June 10, 2014
BOARD OF COUNTY COMMISSIONERS
ORANGE COUNTY, FLORIDA

ADDENDUM NO. 5
BID NO. Y14-792 PH IFB
EAST SERVICE AREA POTABLE WATER AND RECLAIMED WATER
STORAGE AND REPUMP FACILITY

ORANGE COUNTY
 EAST SERVICE AREA POTABLE WATER AND RECLAIMED WATER STORAGE AND REPUMP FACILITY
 ELECTRICAL
 ELECTRICAL SINGLE-LINE DIAGRAM

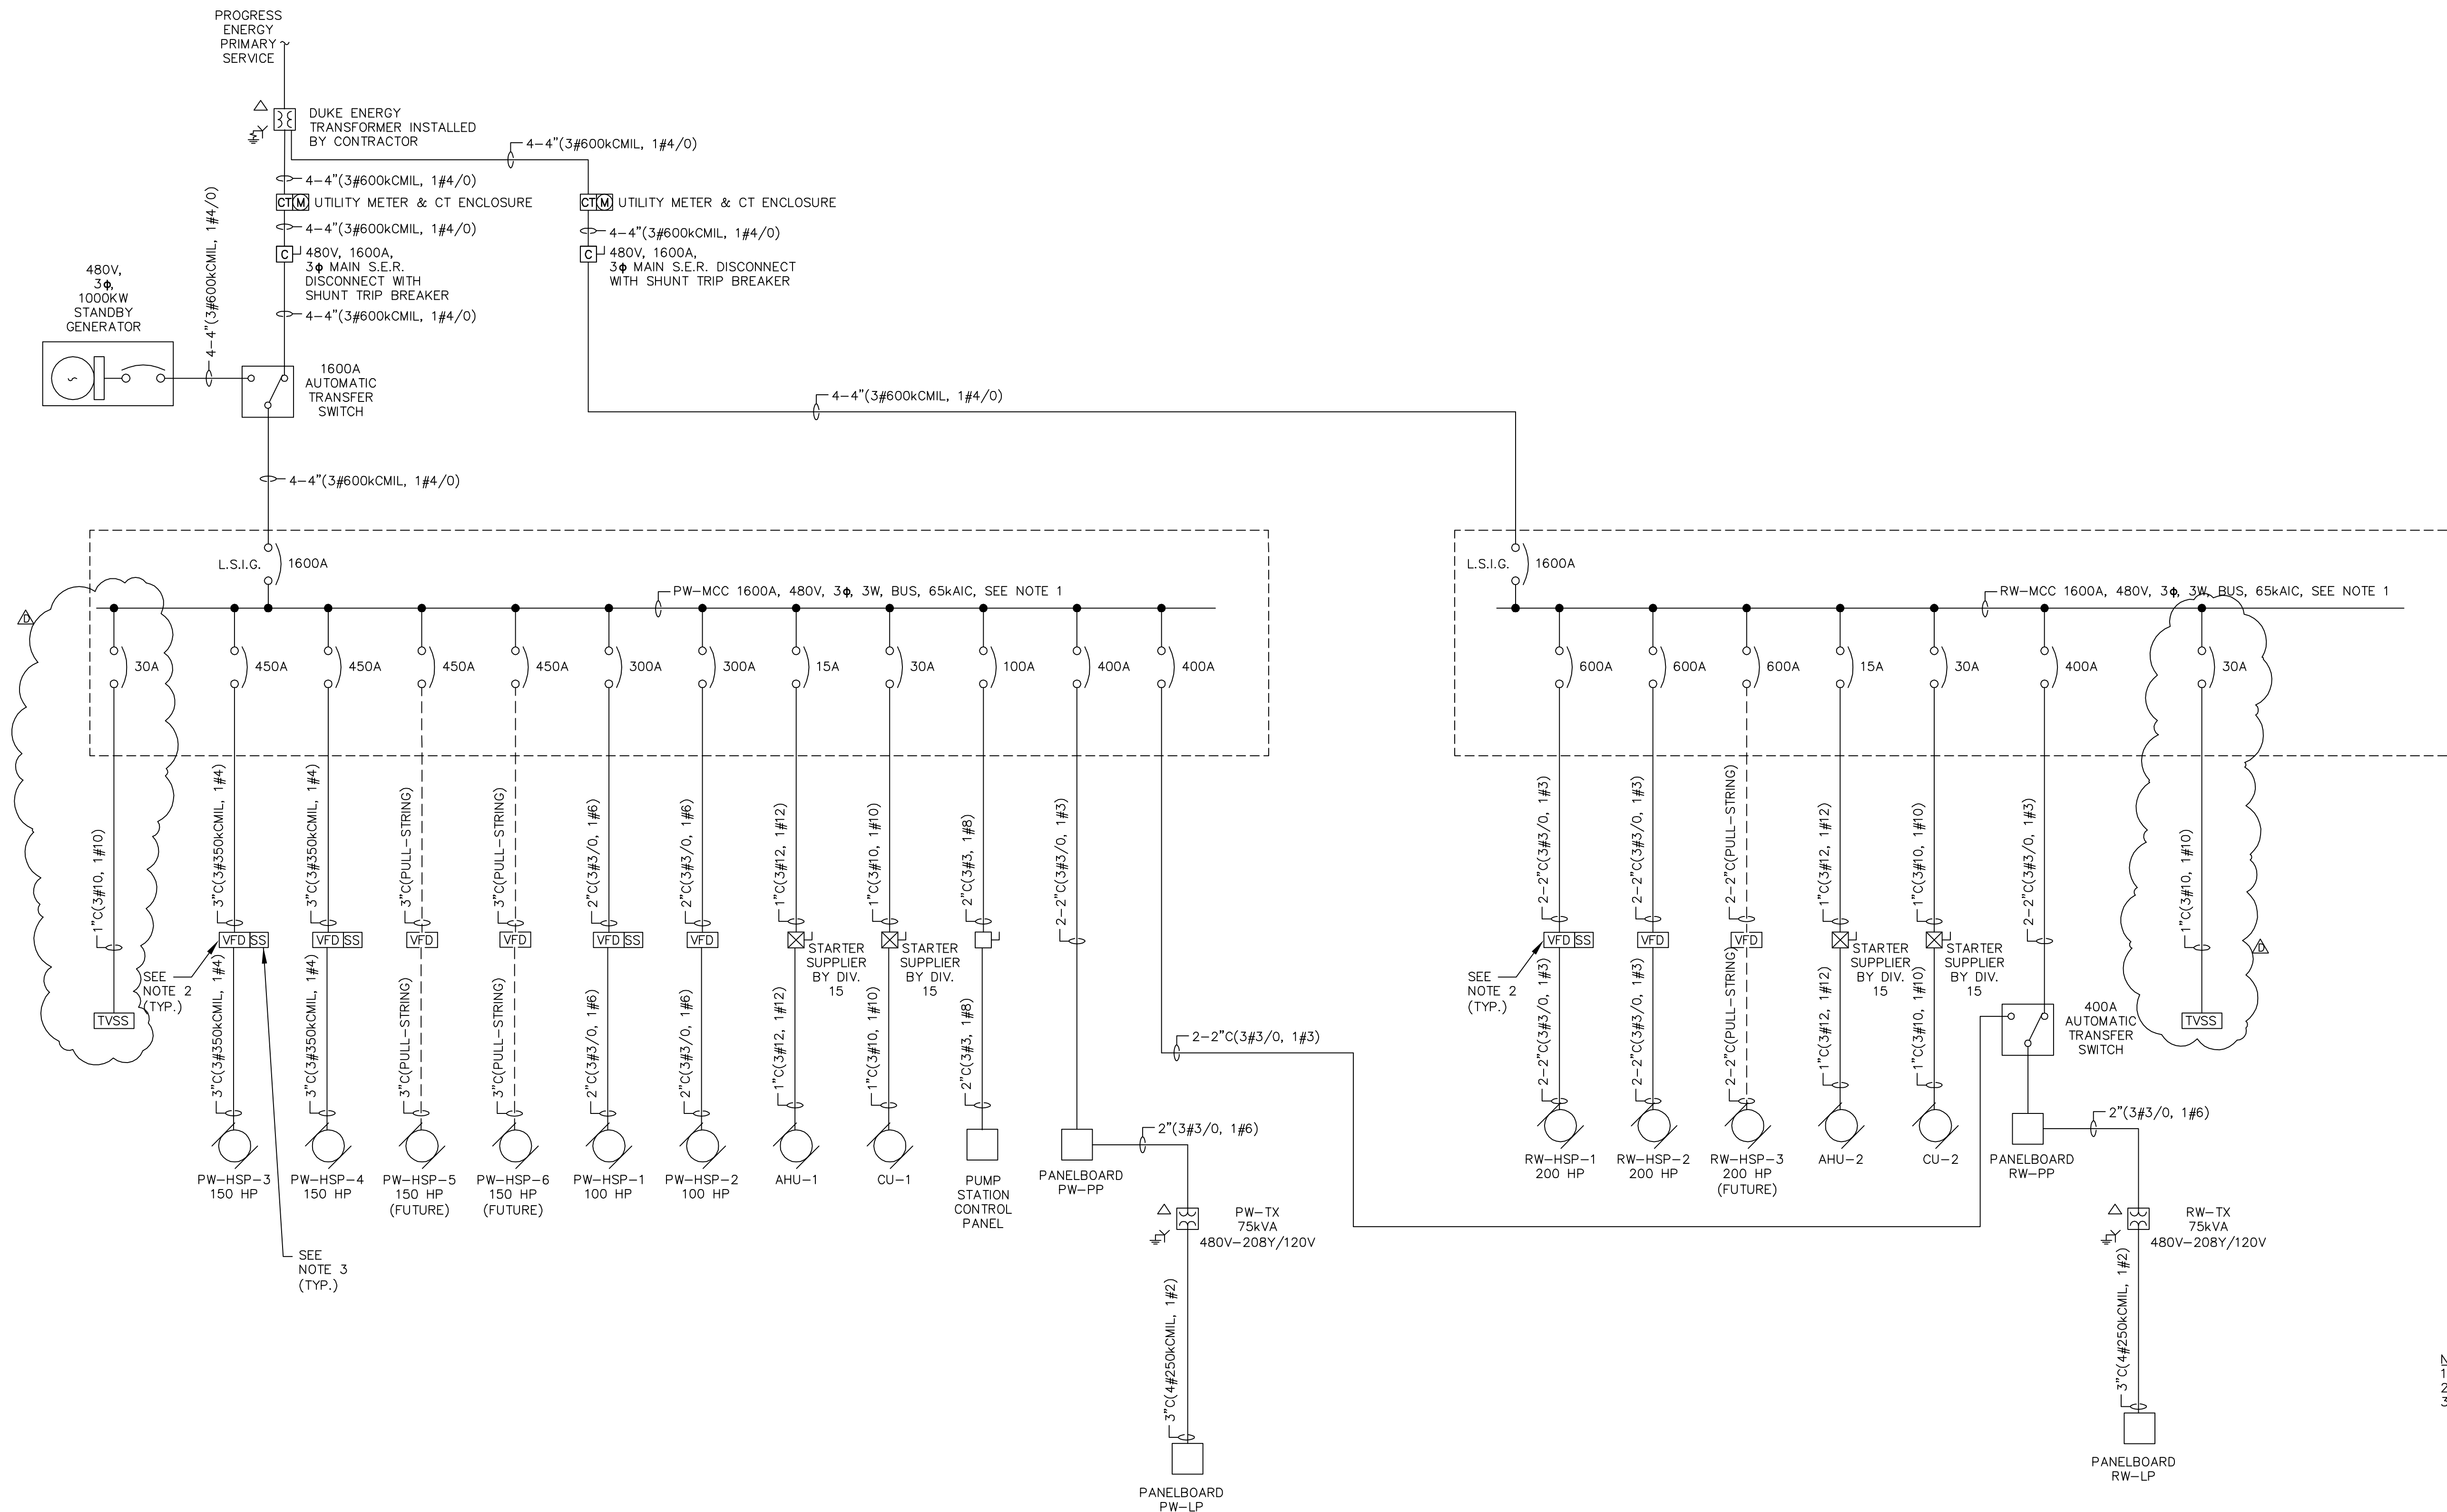
- 2. Surge protection is not shown on MCC or the main breakers. Please advise if it is required. If yes please furnish the make and model.**

Answer: Surge protection shall be provided for service entrance equipment per specification Section 16050, paragraph 2.21 starting on page 16050-18. Surge protection devices on the service entrance equipment are called out on revised Drawing E04, ATTACHED.

1. Drawing No. E04

REPLACE Drawing E04 with revised Drawing E04, ATTACHED.

- NOTES:
 1. PROVIDE PQM ON EACH MCC.
 2. VFD SHALL HAVE ABILITY FOR MONITORING BY ETHERNET.
 3. SOLID STATE BYPASS.
